**STATEMENT OF MODIFICATION - APPLICATION TO MODIFY CONSENT UNDER  
S4.56 OF THE ENVIRONMENTAL PLANNING & ASSESSMENT ACT 1979**

**DEMOLITION WORKS AND CONSTRUCTION OF A SENIORS HOUSING DEVELOPMENT**

**1955 PITTWATER ROAD, BAYVIEW**

**Prepared  
May 2024**

Figure 1: Unit 1 approved and modified floor layout

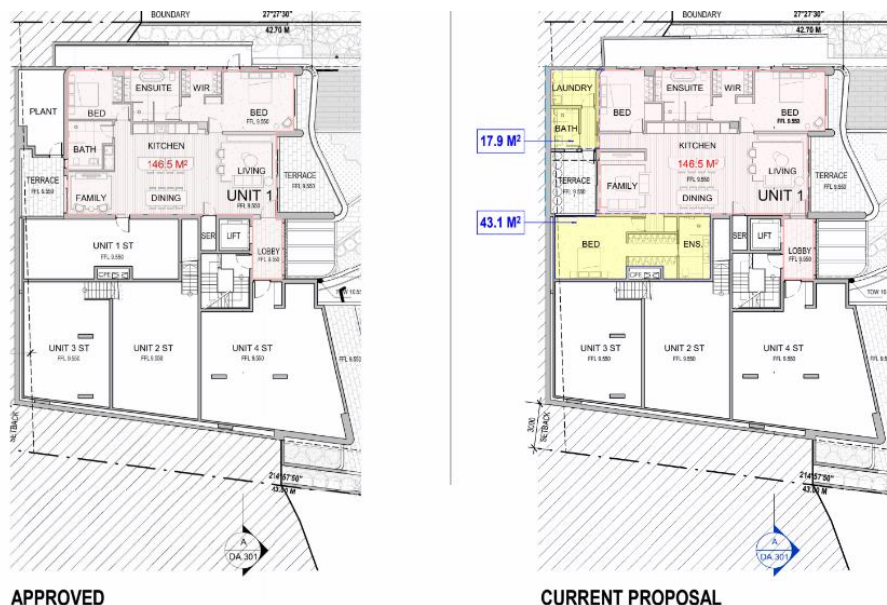
**Lower Ground Floor:** Reconfiguration of Unit 1 to create a new bedroom, WIR and ensuite in the existing storage area, along with a new bathroom and laundry area. The reconfiguration results in a new window servicing the new bathroom, however this window is orientated inwards to the terrace area, not towards any site boundary.

The modified development has been designed having regard to the visual and acoustic privacy of both the future residents of the development together with the adjoining property owners. There is no change to the existing building setbacks, with the only new window opening facing inwards to the existing terrace area.

In terms of internal visual privacy for future occupants the additional window for Unit 1 does not create amenity impacts beyond what was previously approved.

Figure 2: Unit 4 approved and modified floor layout

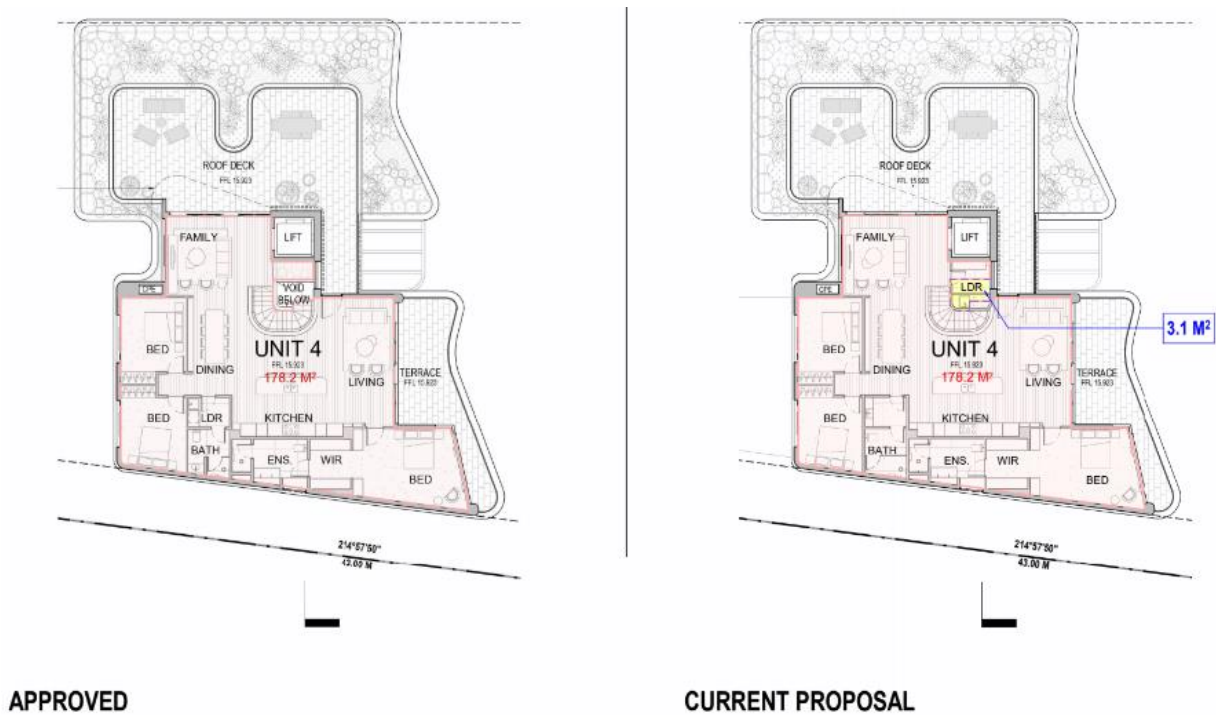
**First Floor:** Reconfiguration of Unit 4 to create a larger bathroom and relocate the laundry to the void area.
